SUBJECT: Forwards marked-up final draft Tech Specs & itemized list of corrections. *S66 TECH SPGS*

Subject: PVNGS Unit 1
PVNGS Unit 1 Final Draft Technical
Specifications
Docket No. STN 50-528
File: 005-419.05

This letter is submitted for the purpose of (i) transmitting a marked-up copy of the "Final Draft" Technical Specifications (Attachment A) and an itemized list of corrections included in such marked-up copy (Attachment B) and (ii) providing our certification respecting Attachment A.

FIGURE 3.2-3
REACTOR COOLANT COLD LEG TEMPERATURE vs CORE POWER LEVEL

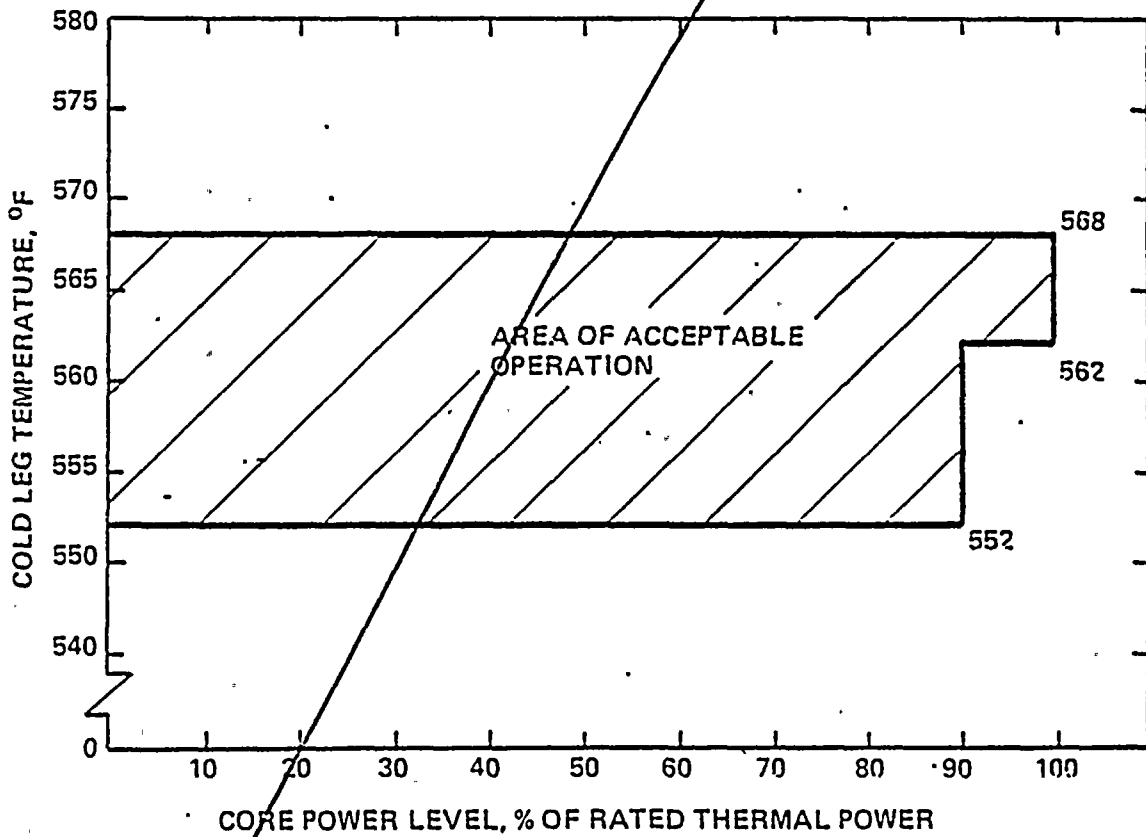
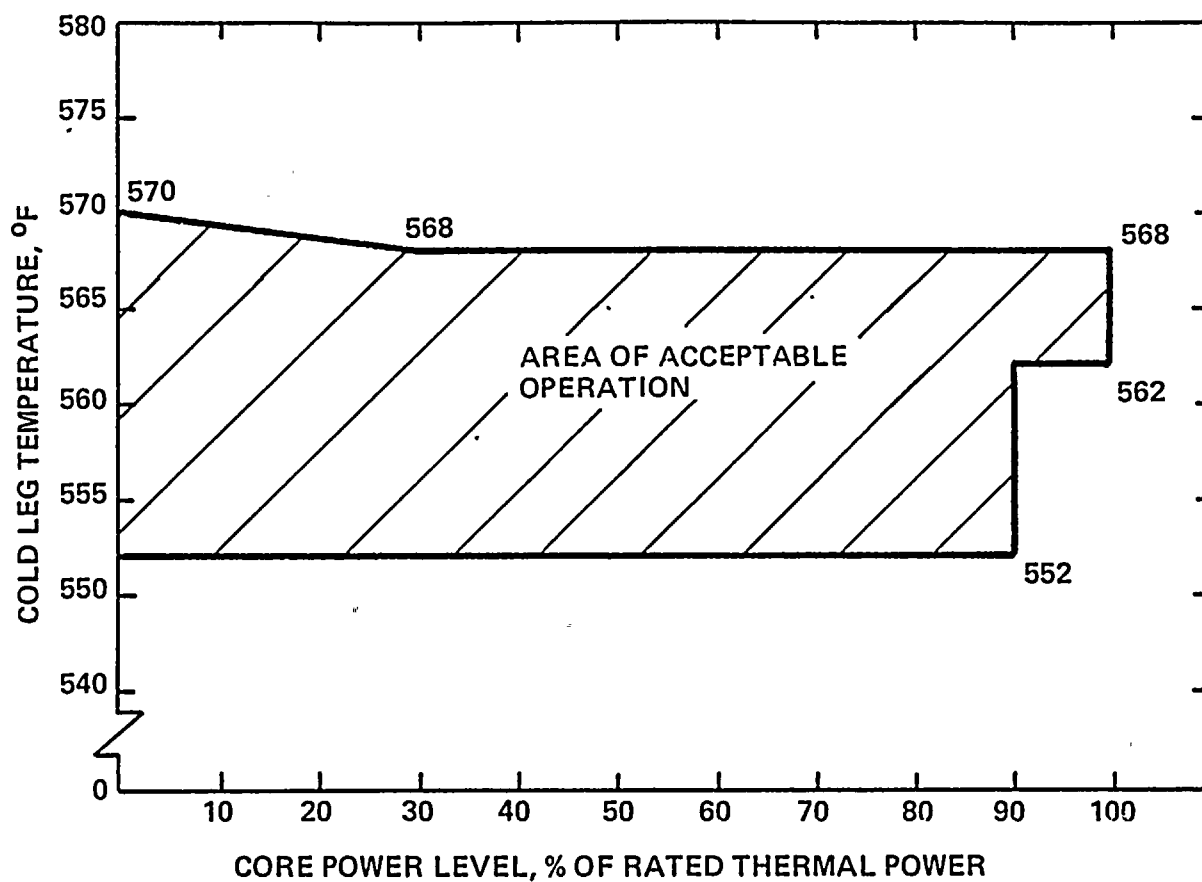
SEE
NEW
GRAPH

SITE AND EXCLUSION BOUNDARIES
FIGURE 5.1-1

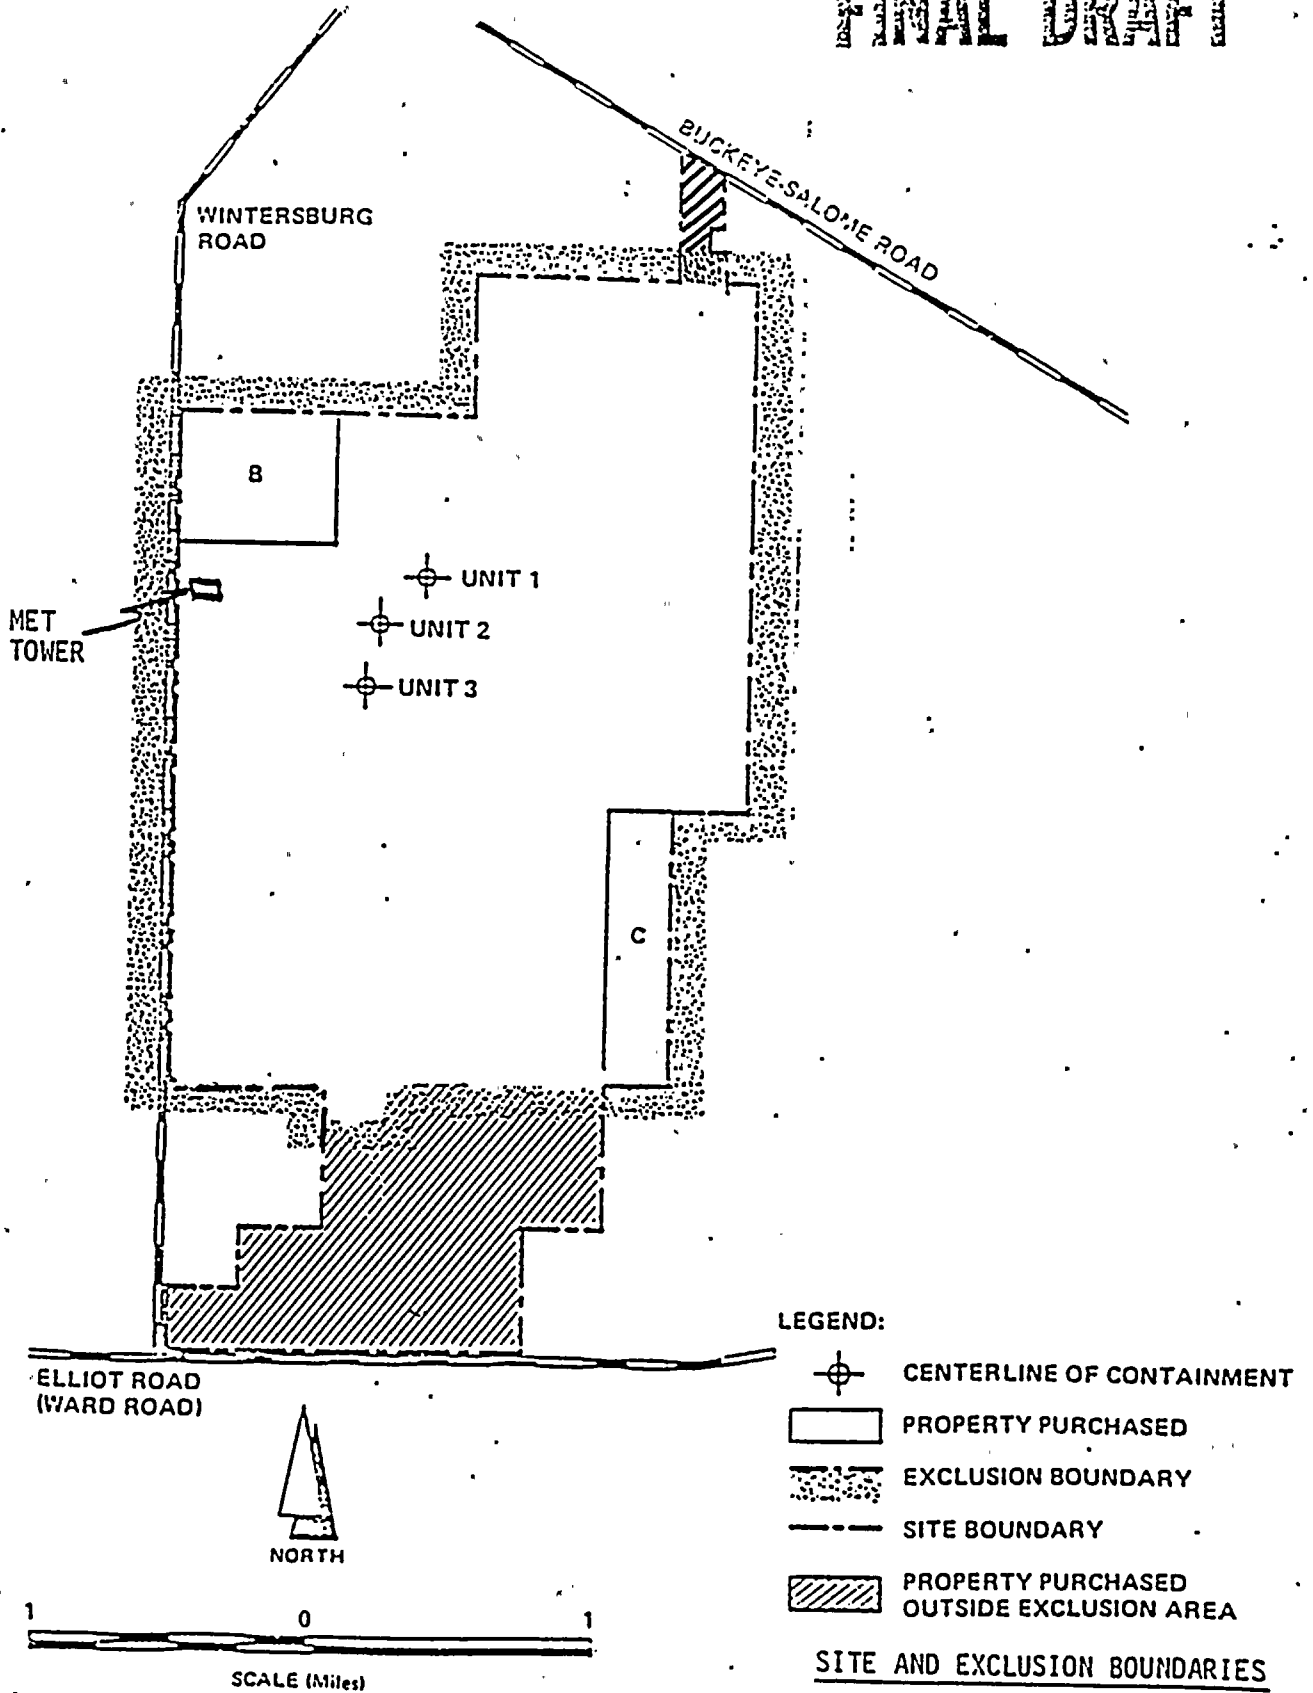
<u>PAGE</u>	<u>COMMENTS</u>
3/4 10-5	Add comments on pressure in LCO. This is needed due to our initial criticality conditions.
3/4 11-5	LCO add Figure 5.1-1.
3/4 11-8	Item C Delete W for charcoal and particulate and add 4M. This will eliminate of taking double samples when the quarterly and weekly sample are required at the same time, to sample the same thing. This change has been granted to St. Lucie Unit 2 for the same reasons.
3/4 11-10	Item d delete "once per 7 days" and add "4 times a month" to make consistent with Table 4.11.2.
12-8	Tritium and add * note as done on page 12-7 except replace 30,000 with 3000. This change was previously granted but was apparently dropped in typing.
5-2	New Figure.
